Colorado Department of Health

Hazardous Materials and Waste Management Division

Comments to: Final Phase I RFI/RI Work Plan for OU-13

April 1993

FIGURE 6-3

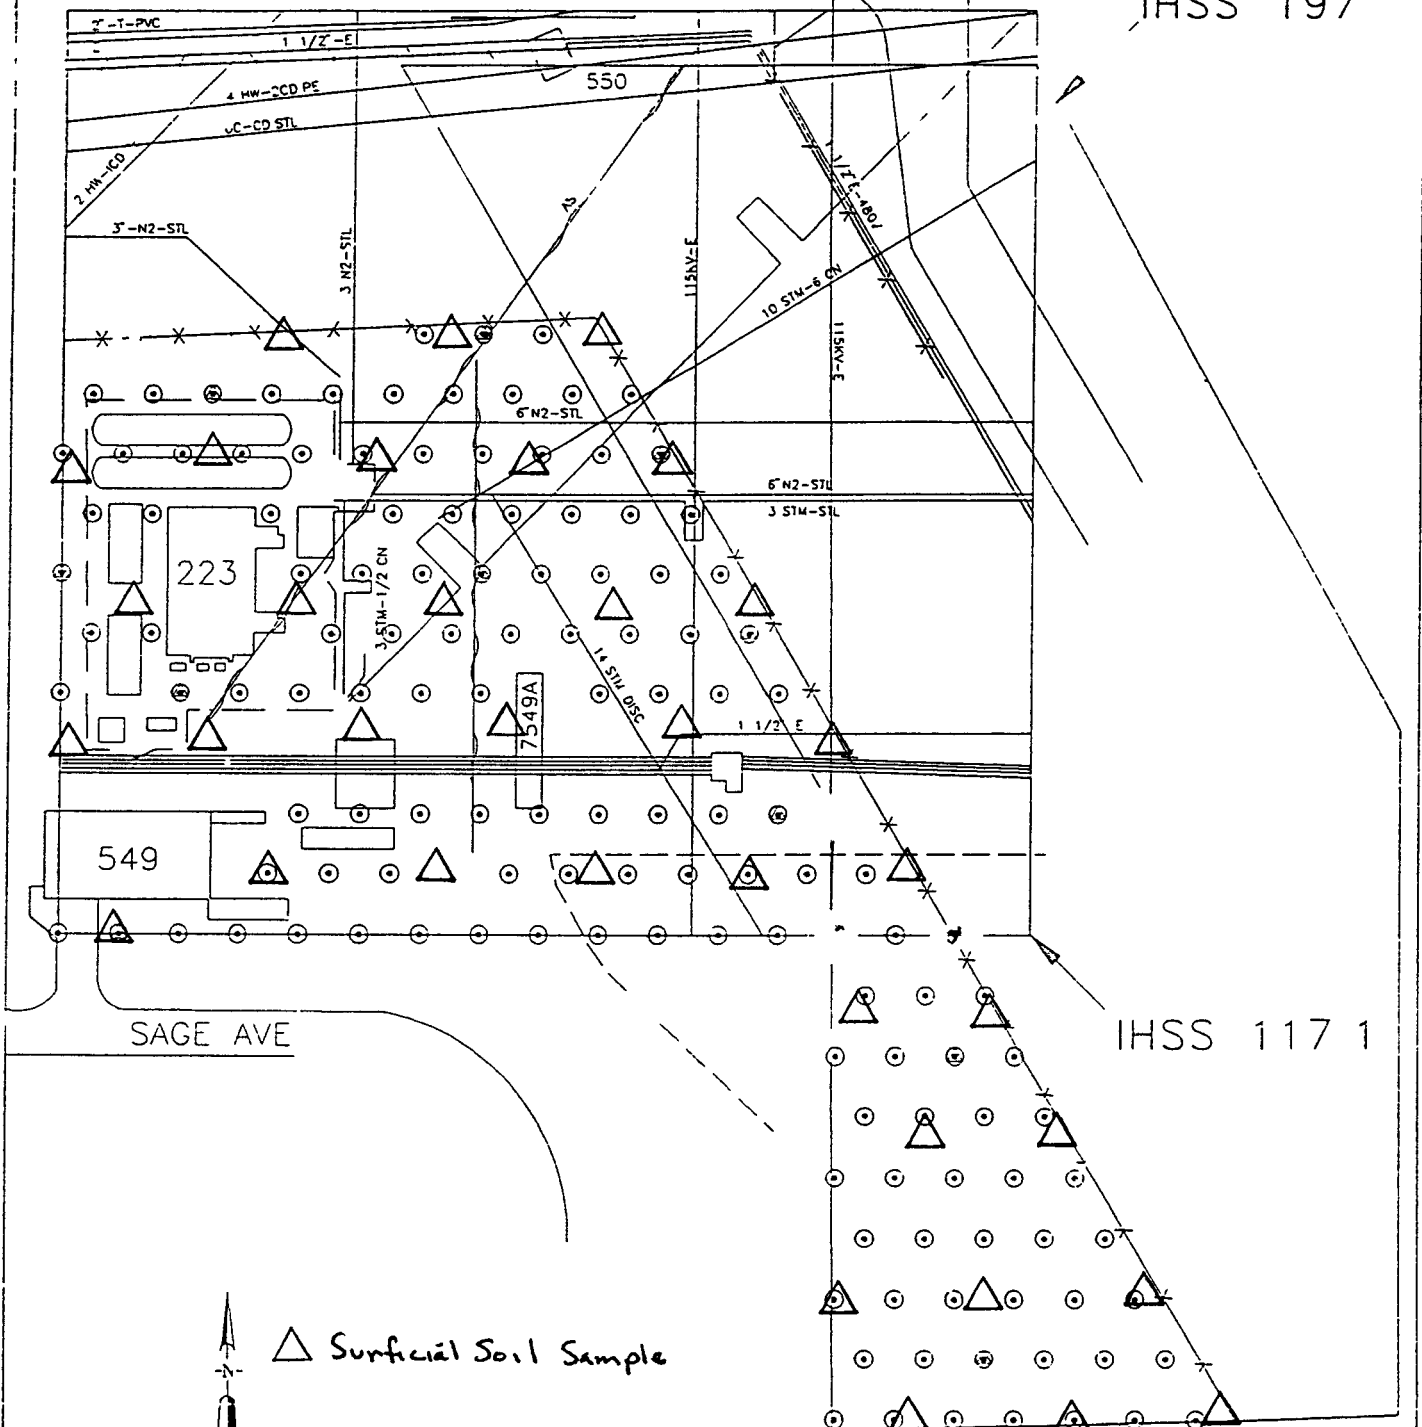
- 1) The Division disagrees with the deposition of our comments regarding the number and location of surficial soil samples (Comment CDH #8, November 10, 1992). The statistical basis for the number of surficial soil samples, as presented in response to our comment, is not considered by the Division to be a valid approach to meeting any of the stage 1 objectives. The Division does not believe that a sufficient number of surficial soil samples have been proposed to assure that the stage 1 objectives will be attained. The statistical approach for the surficial soil field sampling plan should be consistent with EPA Guidance and approved RFI/RI Workplans for similar OUs at the Rocky Flats Plant. This can be done by: 1) replacing Section 5 1.2 5.3 with the revised section contained in Attachment I; 2) modifying Table 6.2 and Figures 6-3 through 6-10 as shown in Attachment II, and 3) revising the text in section 6.3 as necessary to be consistent with items 1 and 2, above.

This Attachment contains modifications to the following Table and Figures of the Final RFI/RI Work Plan for OU 13 - The 100 Area as discussed in Issue 1 - Surficial Soil Sampling Plan

FIGURE 6-8

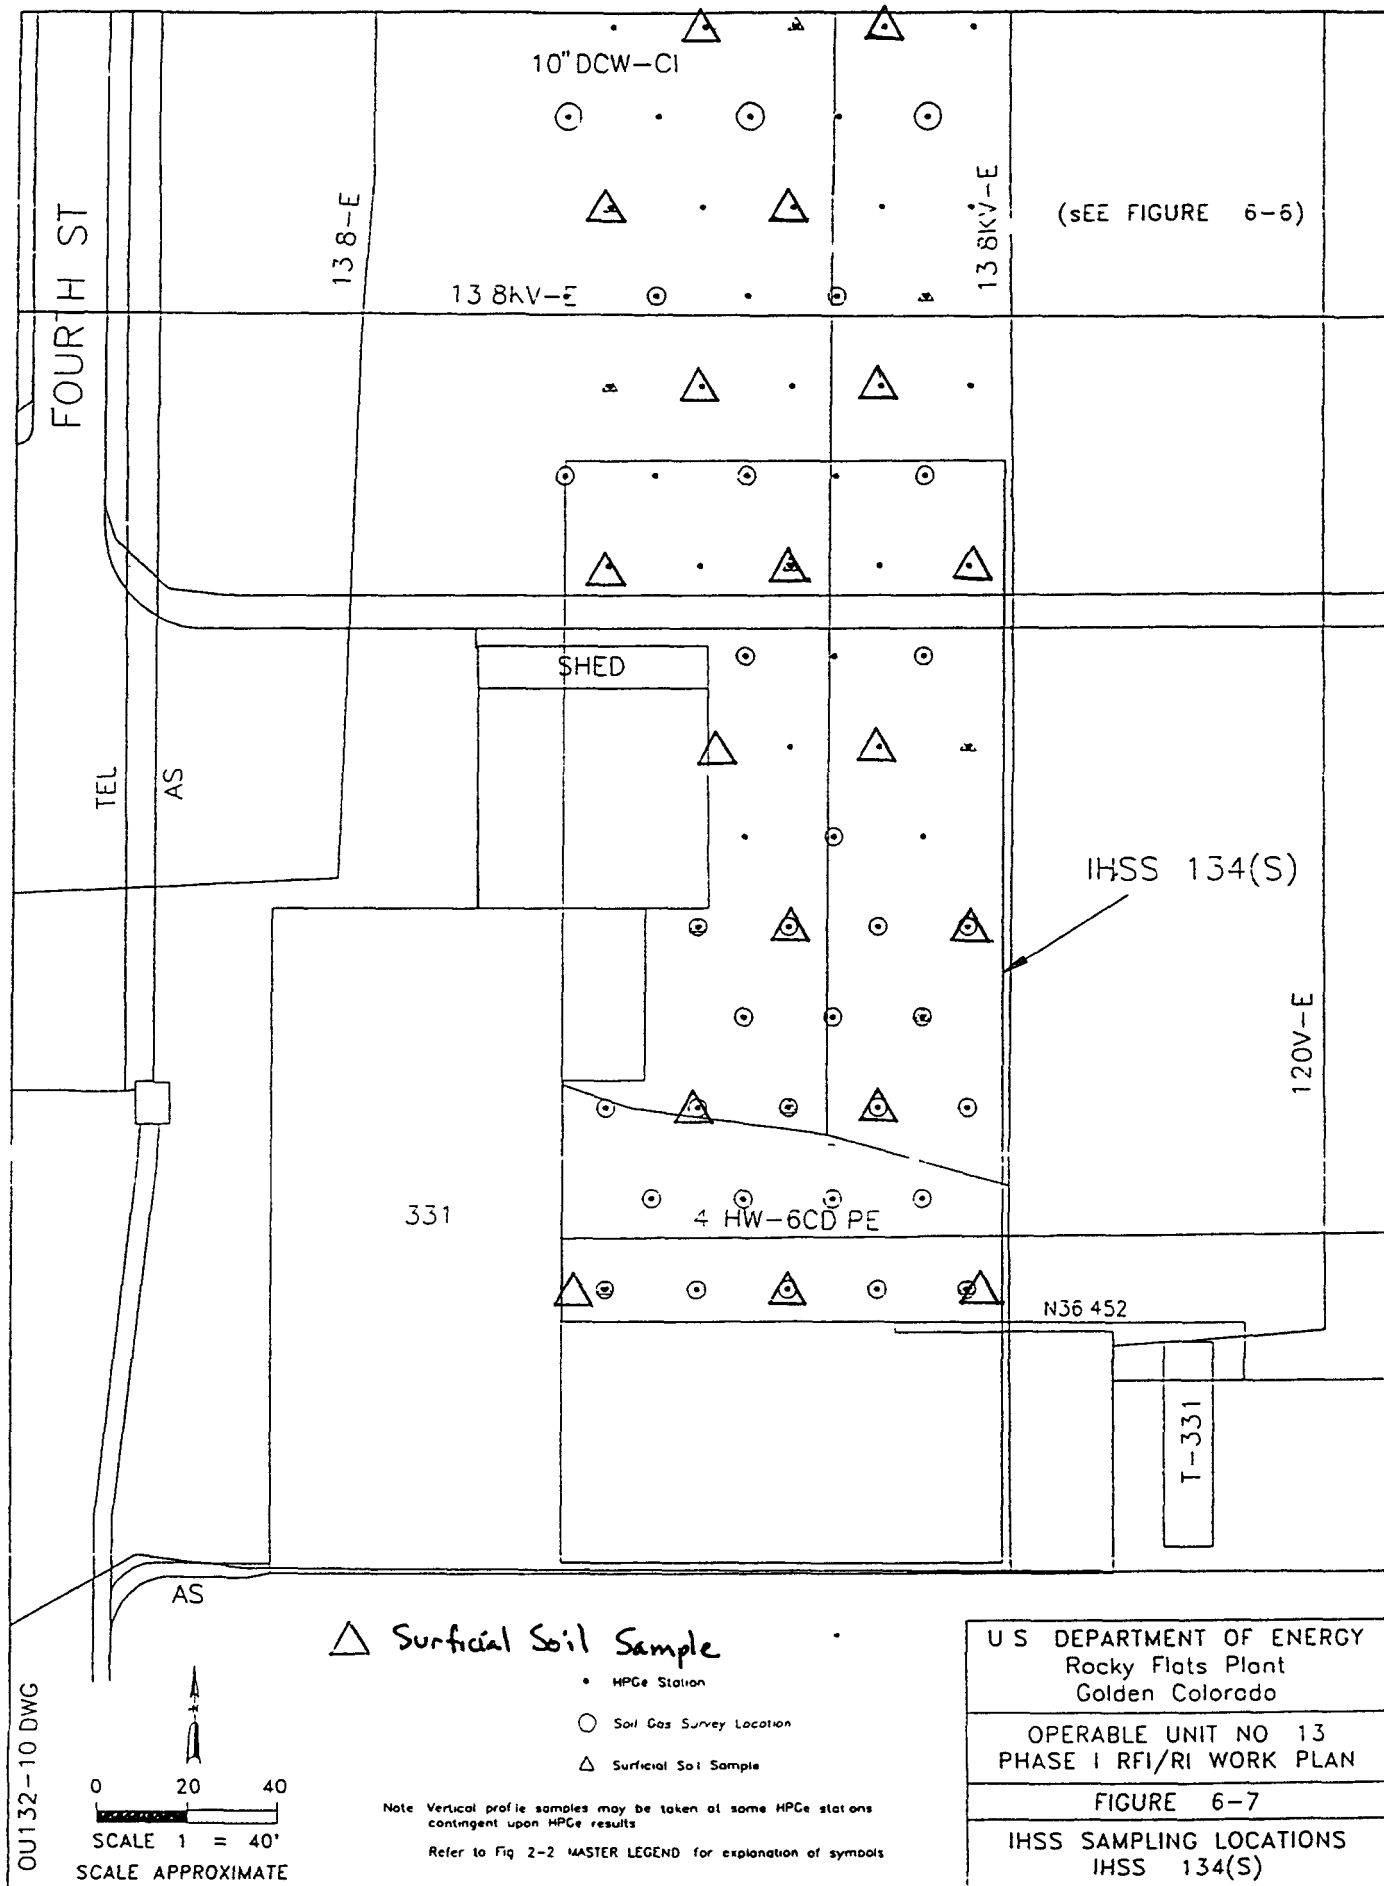
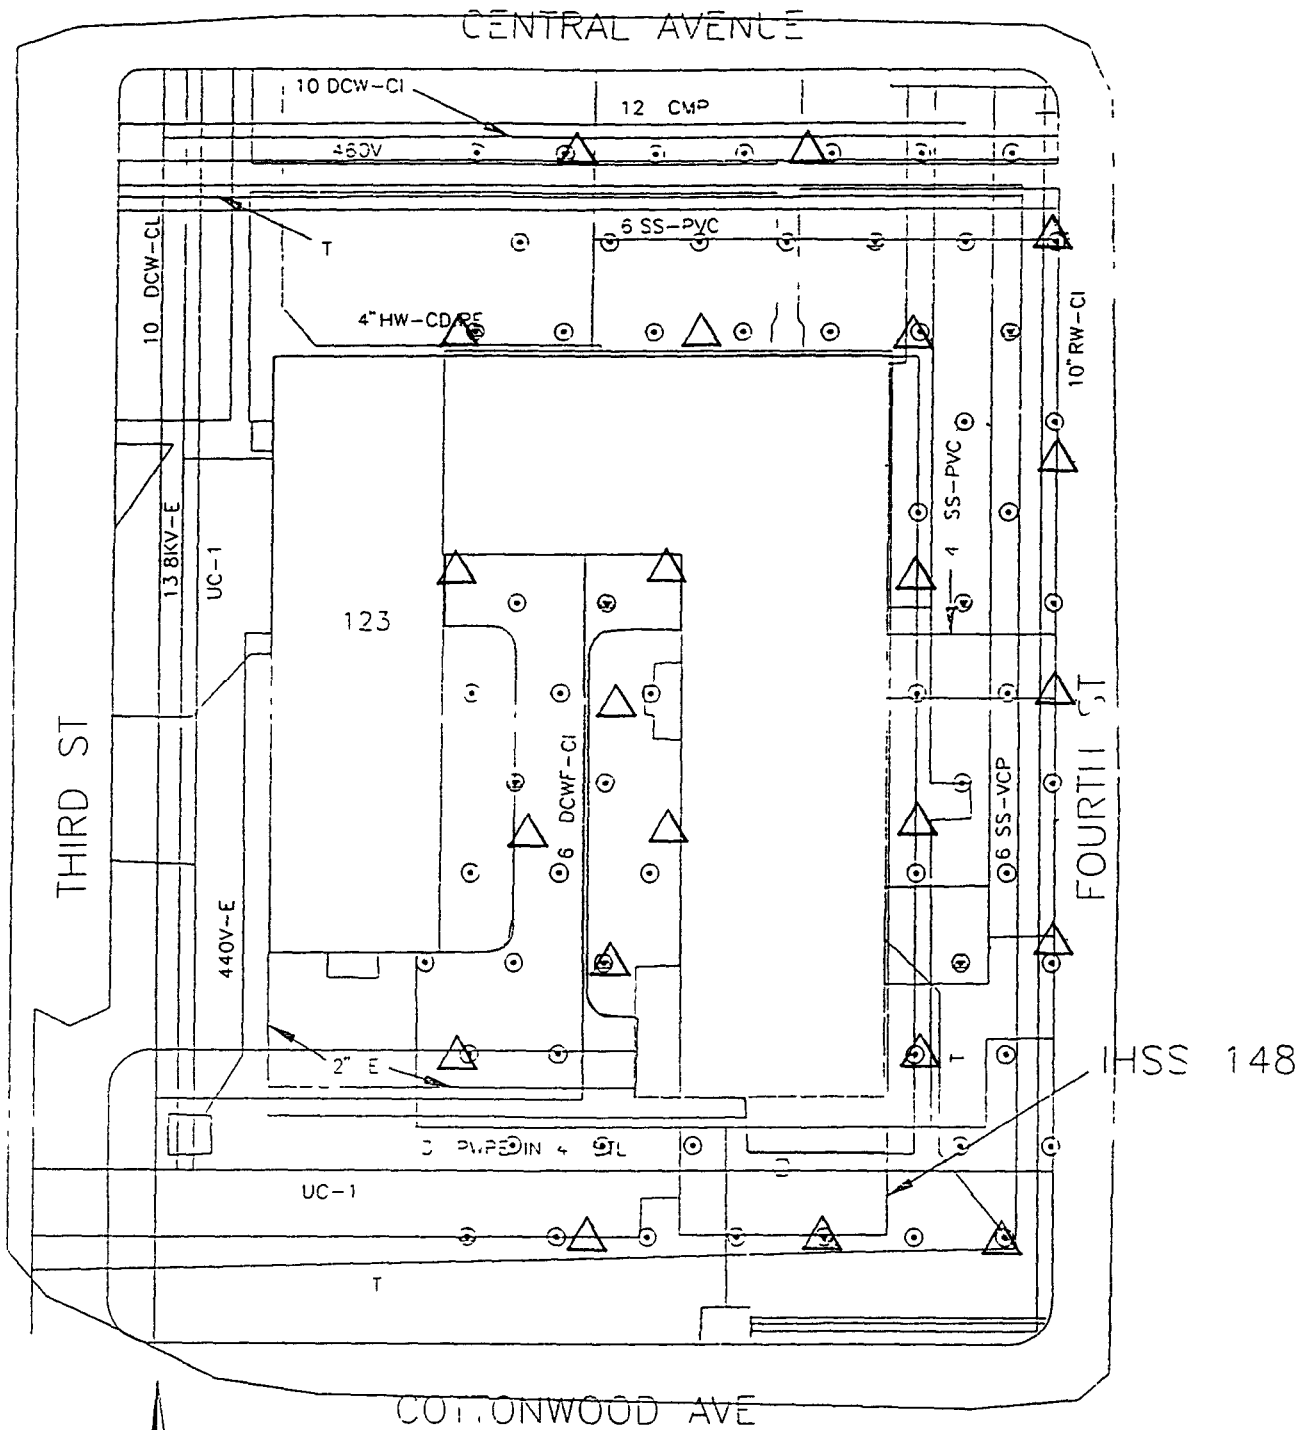
- 2) Modification to the Workplan in response to CDH Comment #8(b) does not appear to be consistent regarding magnesium and beryllium at IHSSs 134(s) and 148. Soil at IHSS 134(s) will be analyzed for magnesium as indicated in Table 6-4, however this modification has not occurred in the text (page 6-44). IHSS 148 must be analyzed for beryllium, this is not indicated in Table 6-4 but has been addressed in modification to the text on page 6-51. Please correct these discrepancy between Table 6-4 and the text of the Workplan so that it is clear the Division's comment has been adequately addressed and that magnesium will be analyzed at IHSS 134(s) and beryllium will be analyzed at IHSS 148.
